Re: Violet Hill Gravel Pit, Town of Mono  
Burnside Review Comments of February 9, 2018

**Re: Greenwood Pit - Town of Mono  
Peer Review – Traffic Study  
Project No.: 300039415.0000**

**Re: Violet Hill Gravel Pit, Part Lots 30, 31, 32, Concession 4EHS, Town of Mono  
Third Line Entrance Drainage Review**

ACCESS ROAD PLAN

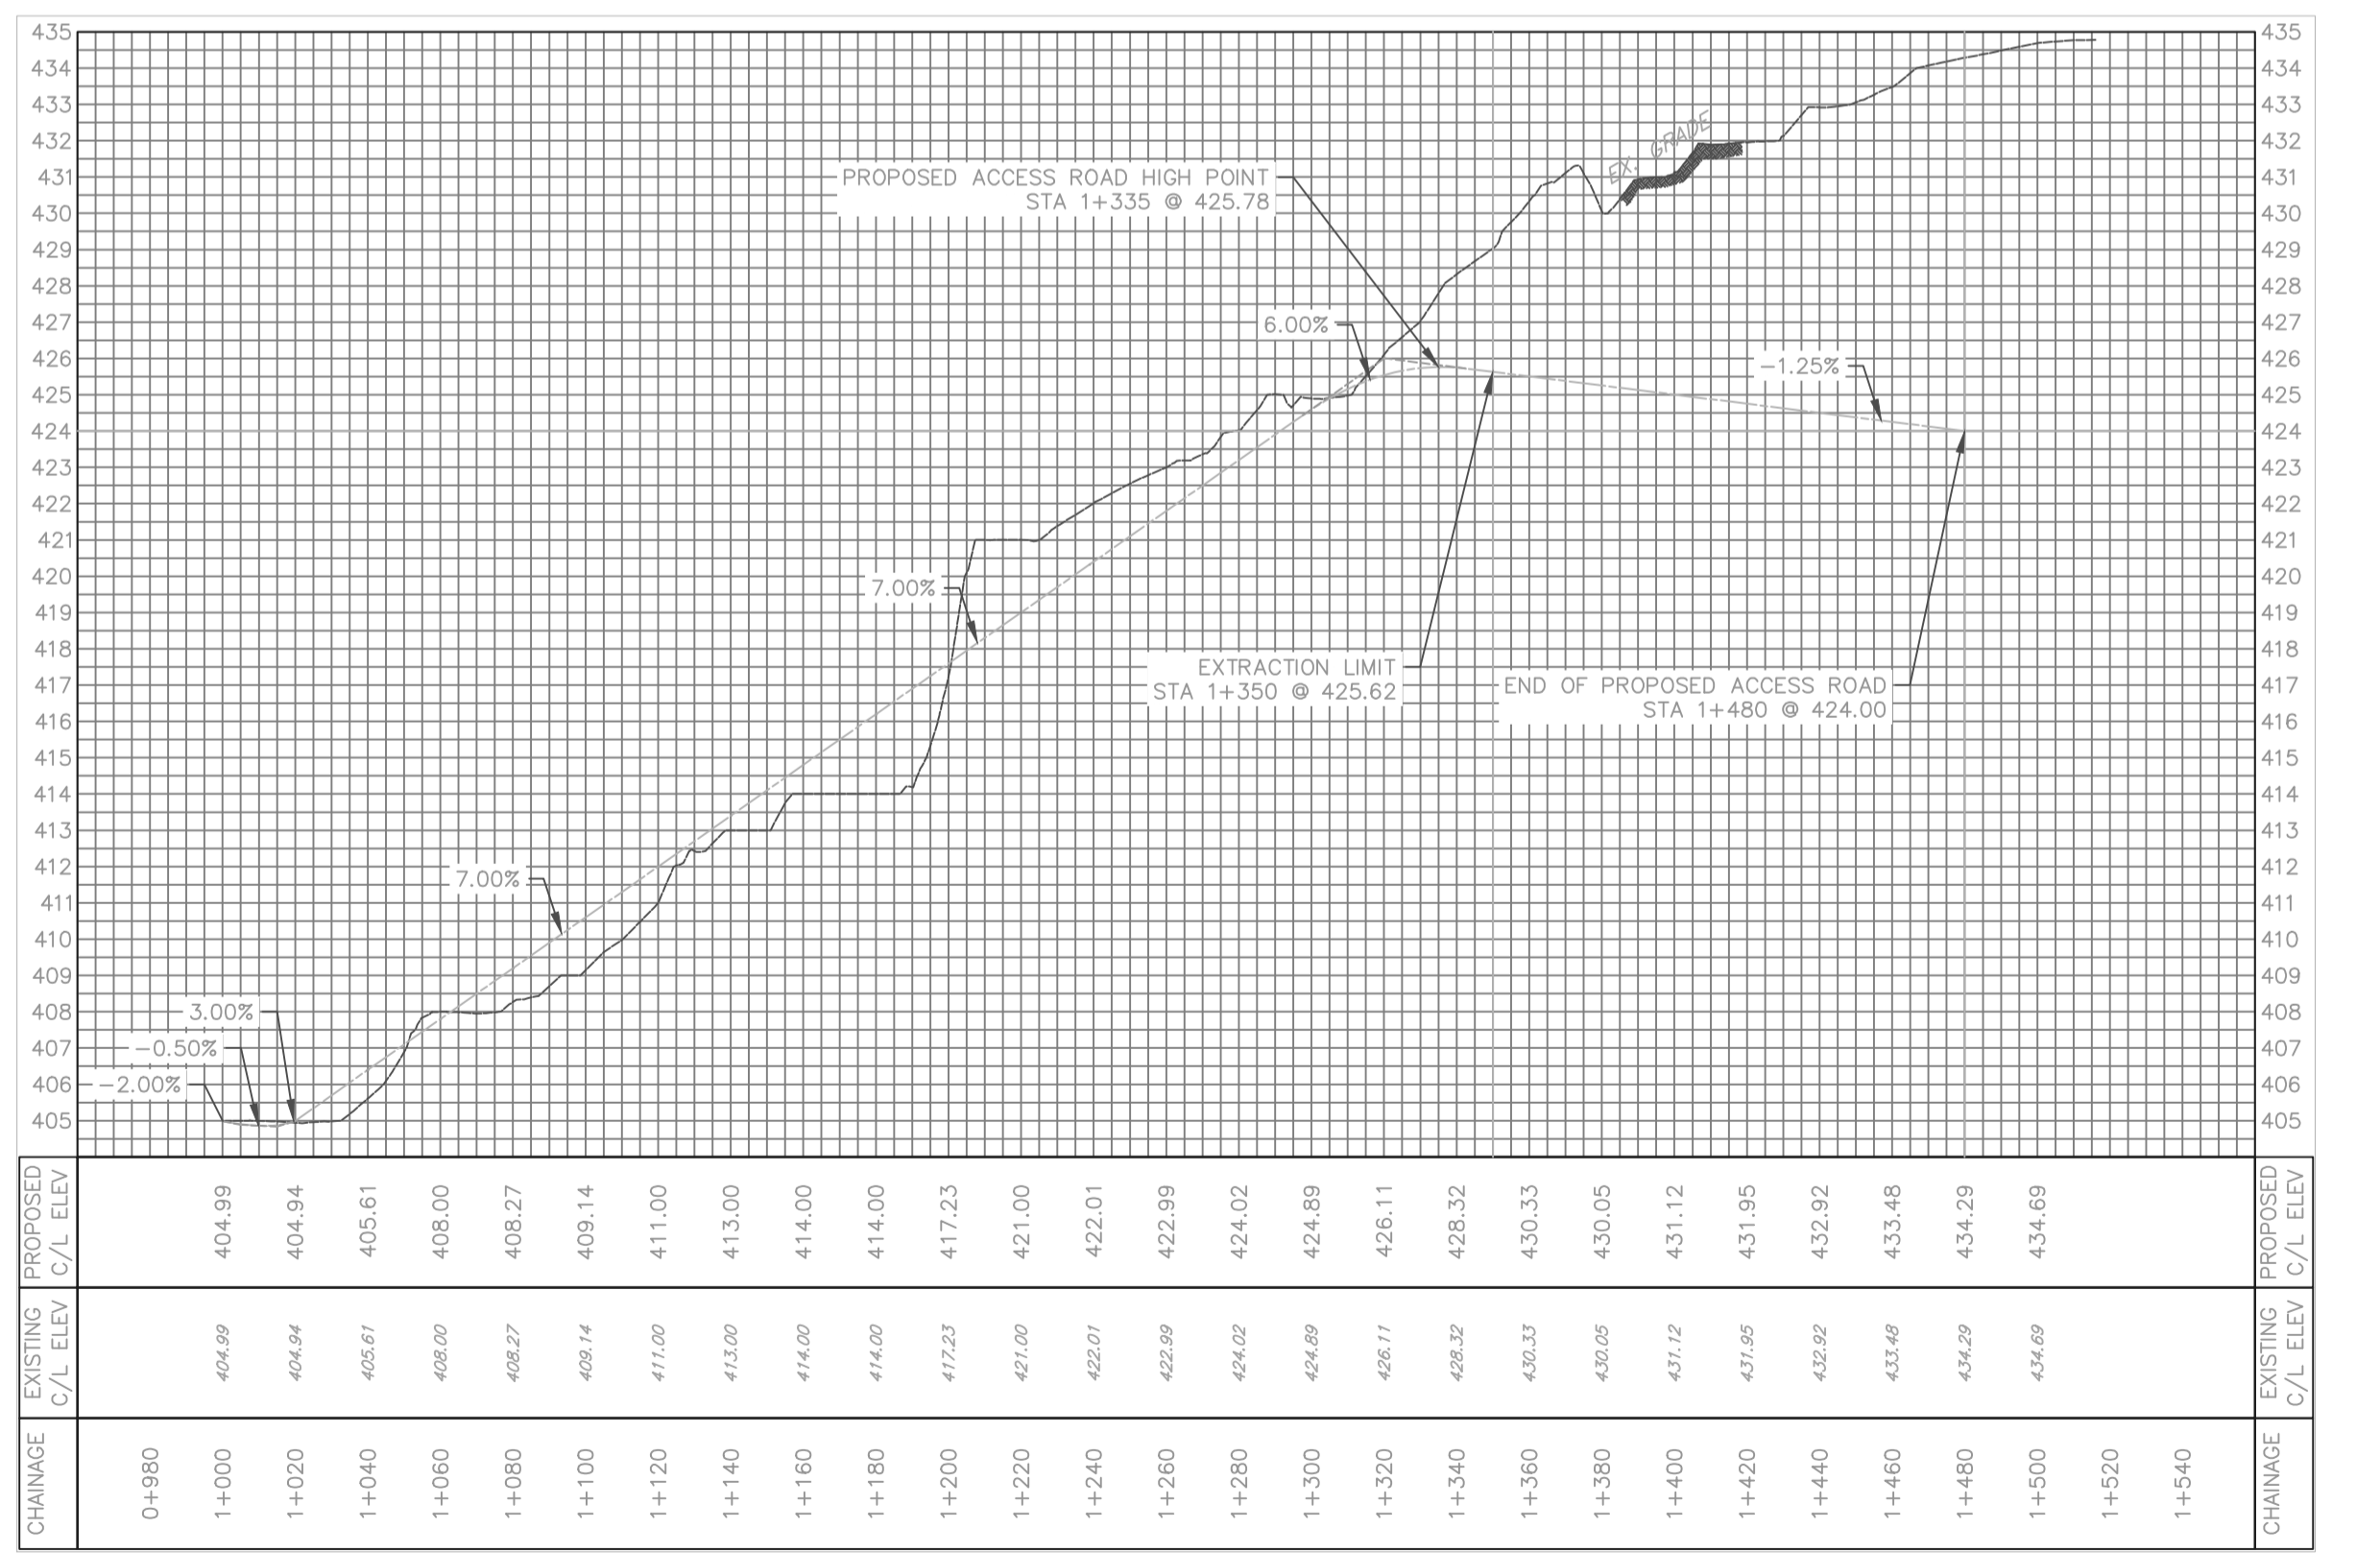
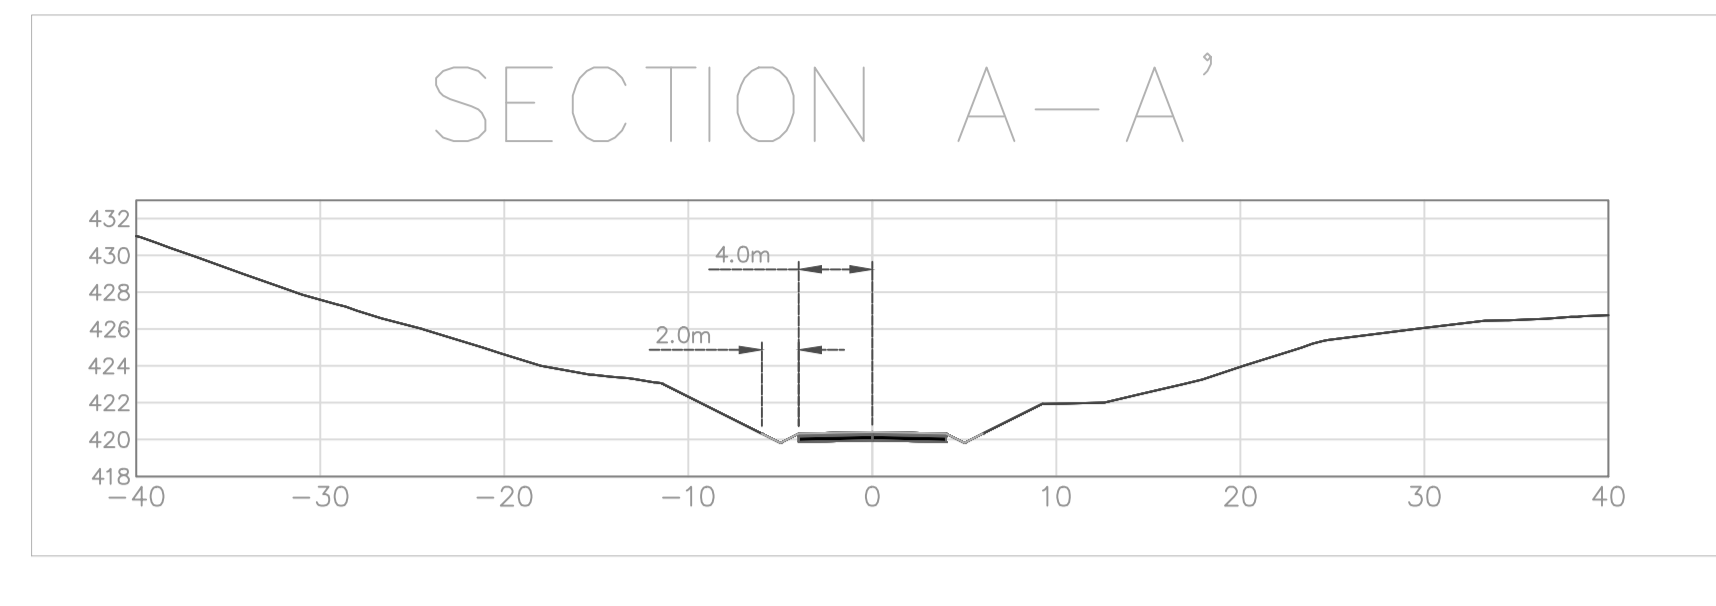
The Erosion Update illustrates on Drawing AR-1 a profile of the driveway. The profile has stationing, but the plan view does not provide stationing; therefore, it is not possible to coordinate between the plan and profile.

The driveway proposes to rise at a grade of 7% from near 3<sup>rd</sup> Line East to where it cuts through the land to access the pit. The driveway rises about 20 m in elevation to where it cuts through the land, which rises another 10 m. If we assume that the edge of 3<sup>rd</sup> Line East is at station 1+1000, then the driveway starts to rise at 7% about 20 m from the edge 3<sup>rd</sup> Line East. Once additional details are provided, it can be reviewed.

- Inclusion of MTO items / conditions and that appropriate permits are obtained
- Provide further details on the driveway design given the grade difference of approximately 30 m

Additional details pertaining to the driveway are included in the *Third Line Entrance Drainage Review* letter prepared by C.C. Tatham, dated April 20, 2018. A copy is attached.

The design of the access road has been completed by CCTA and is illustrated on the Access Road Plan (Drawing AR-1) enclosed. The access road enters the site and traverses up the natural draw in the topography at a slope of approximately 7% until it reaches the floor of the first phase of extraction.
